CITY PLANNING DEPARTMENT

Memorandum – FINAL

To: City Plan Commission
From: Jonas U. Bruggemann, MSCRP | Senior Planner
Date: January 29, 2025
RE: 530-532 Wellington Avenue – Assessors Plat 3, Lot 107
“CanAm Self Storage” – Major Land Development Project: Preliminary Plan

Site Plan of Proposal

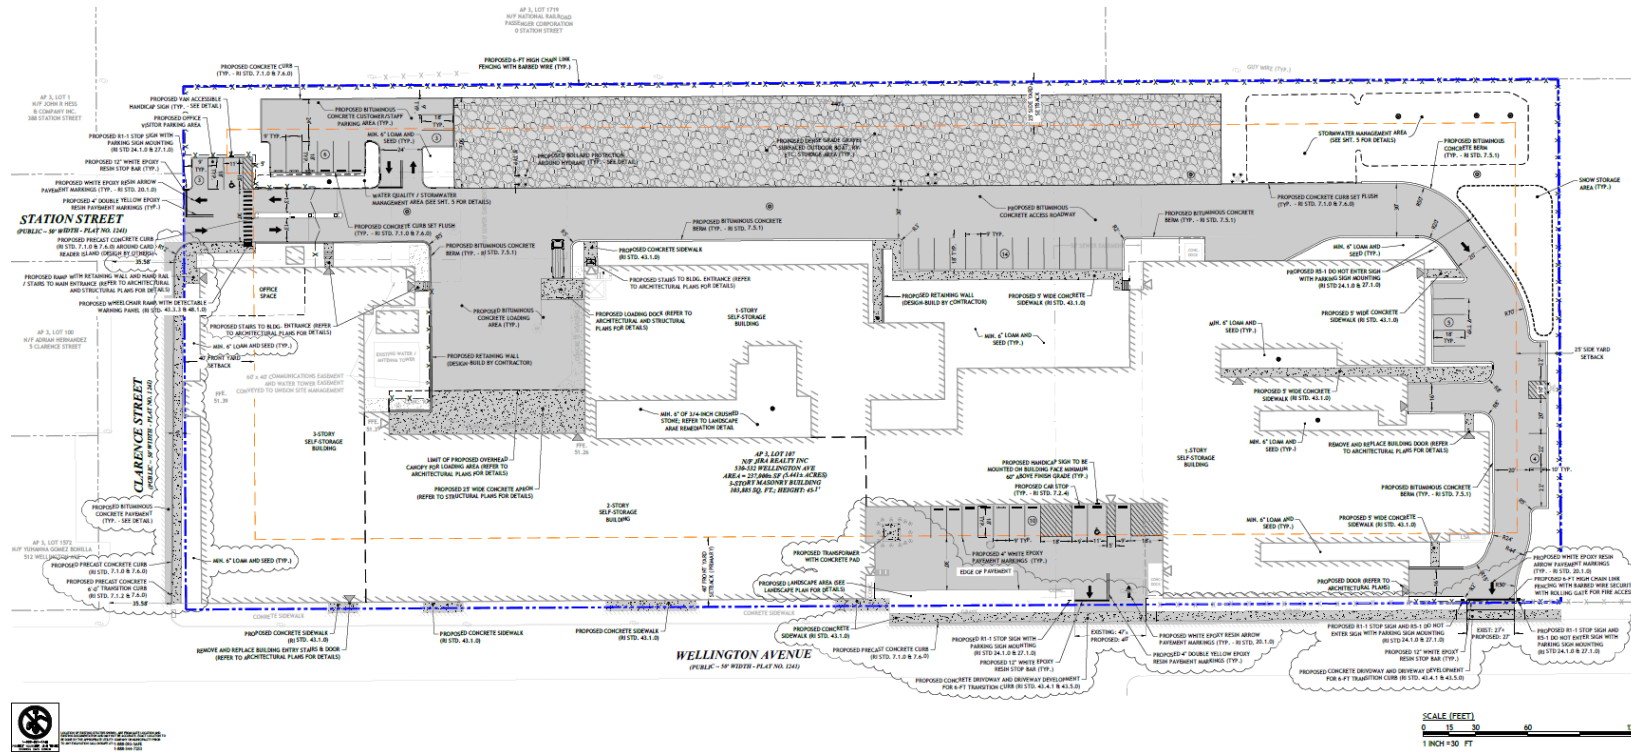
- The proposed transformer in the small parking lot across from Laurens Street was located closer to the building as recommended by RI Energy.

- Curbing and sidewalks should be installed along the public streets and the existing sidewalks and curbing should be brought into compliance with City standards.
 - *New curbing and sidewalks have been provided in the revised plans.*
- The applicant should provide evidence that the portion of Station Street that is now designated as 530 Wellington Avenue has been properly abandoned.
 - *Evidence of proper abandonment has been provided by the Applicant.*
- The fire hydrant on the south end of the property should be assessed.
 - *If the hydrant is in poor condition and beyond repair, it should be removed.*
- The sewer easement along the east side of the property should be abandoned.

- The easement is superfluous and maintaining the easement may create more issues in the future than removing it.
- *The Applicant is in the process of reviewing this option.*
- Signage plans and a structural assessment for the water tower have been requested as part of the permitting process of the Building Department.
 - *These items will be dealt with separately from the Planning approval process.*
